**MONTGOMERY COUNTY HISTORIC PRESERVATION COMMISSION**  
**STAFF REPORT**

<b>Address:</b>	6906 Westmoreland Ave., Takoma Park	<b>Meeting Date:</b>	12/4/2019
<b>Resource:</b>	Contributing Resource (Takoma Park Historic District)	<b>Report Date:</b>	11/27/2019
<b>Applicant:</b>	Adam Gabor and Helena Dagadu (Rick Vitullo, Architect)	<b>Public Notice:</b>	11/20/2019
<b>Review:</b>	HAWP	<b>Tax Credit:</b>	No
<b>Case Number:</b>	37/03-19FFF	<b>Staff:</b>	Michael Kyne
<b>PROPOSAL:</b>	Building addition and other alterations

**STAFF RECOMMENDATION:**

Staff recommends that the HPC **approve** the HAWP application.

***Fig. 1: Subject property.***

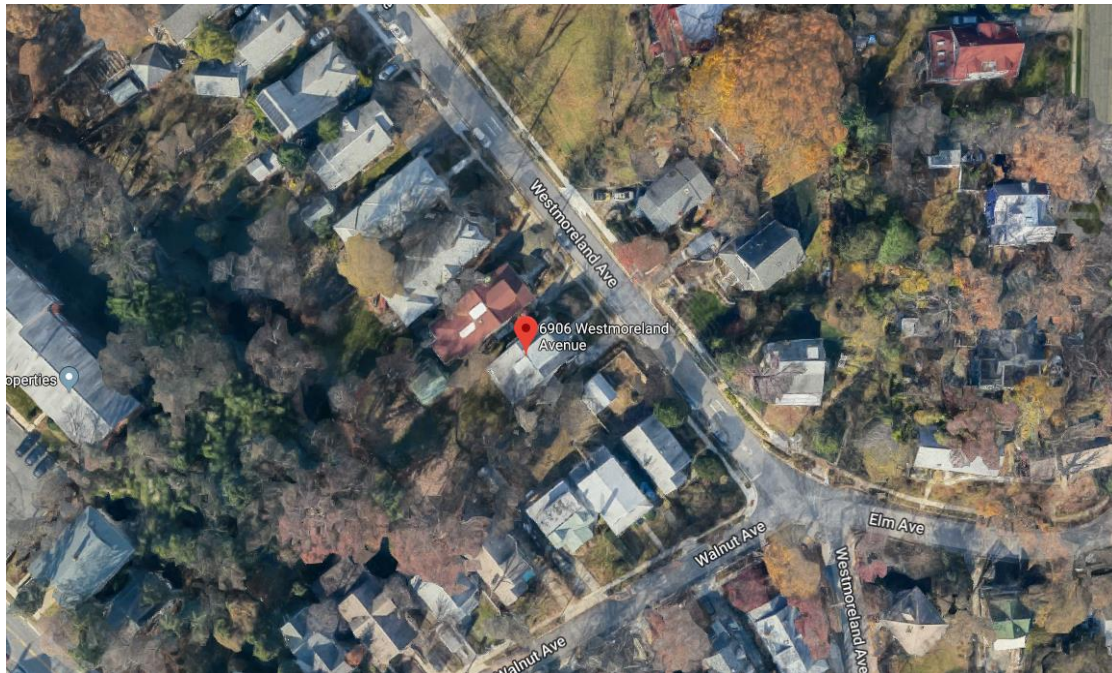
The subject property is a c. 1910-1920s Bungalow-style Contributing Resource within the Takoma Park Historic District. The house has experienced previous alterations, including an existing one-story rear addition with vinyl siding, an existing rear dormer addition, the replacement of many of the original 1<sup>st</sup>- and 2<sup>nd</sup>-floor windows with vinyl windows, and splitting the house into seven different apartments with exterior entrances to all three floors (basement, 1<sup>st</sup>-floor, and 2<sup>nd</sup>-floor). The applicants propose to renovate the house and convert it back into a single-family residence.
